# 990 BROADWAY ST NE MIXED-USE DEVELOPMENT

Re: Consolidated Land Use Application  
Class 3 Design Review, Class 3 Site Plan Review, Class 2 Adjustments  
990 Broadway Street NE

Re: Case No. DR-SPR-ADJ19-10

**TO:** Aaron Panko, Planner III  
Community Development Department

**SP-2**

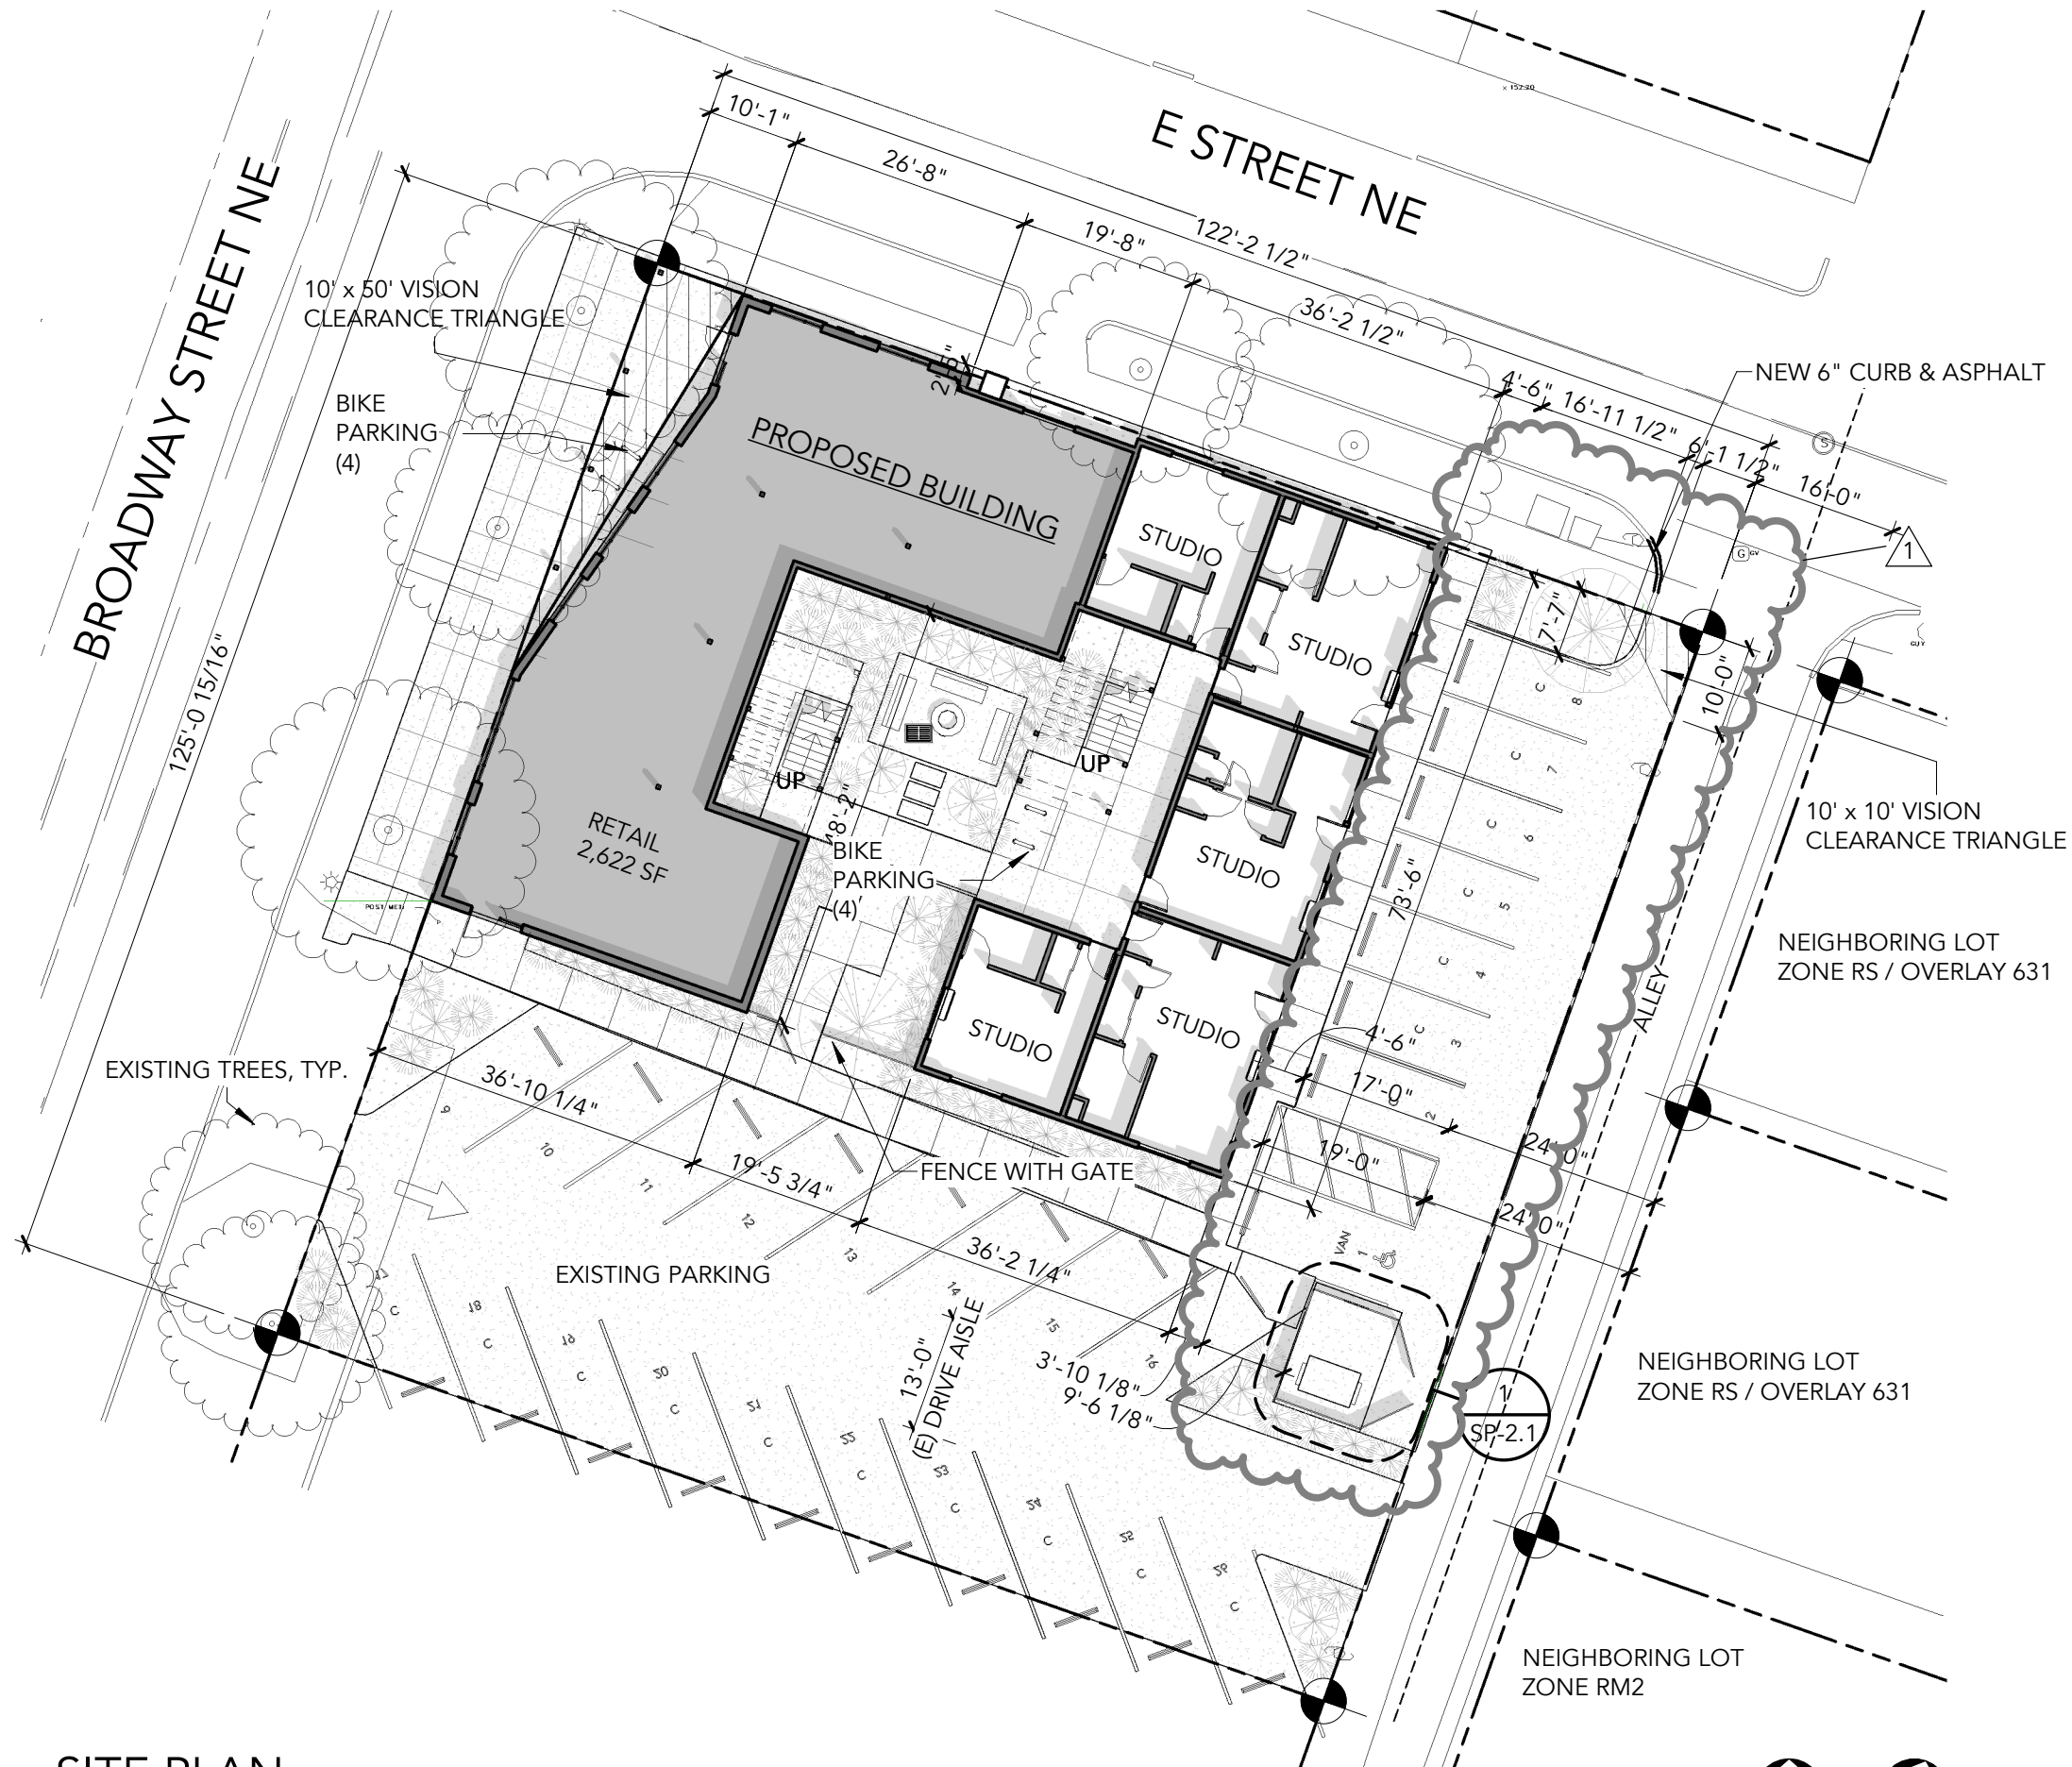
1. Replace the existing alley approach along E Street NE pursuant to PWDS.
2. Close the existing unused driveway along E Street.
3. Obtain awning permits for proposed awnings encroaching into the right-of-way.
4. Replace non-conforming portions of existing sidewalk in conformance with the provisions of SRC Chapter 78 and PWDS.
5. Protect existing street trees during construction in conformance with the provisions of SRC Chapter 86 and PWDS.
6. Proposed bicycle parking within the vision clearance triangle shall comply with SRC Chapter 805.

The proposed plan shows awnings encroaching into the right-of-way. The applicant shall obtain awning permits. The proposed plan also shows bicycle parking spaces within the vision clearance triangle. The bicycle parking shall comply with SRC Chapter 805.
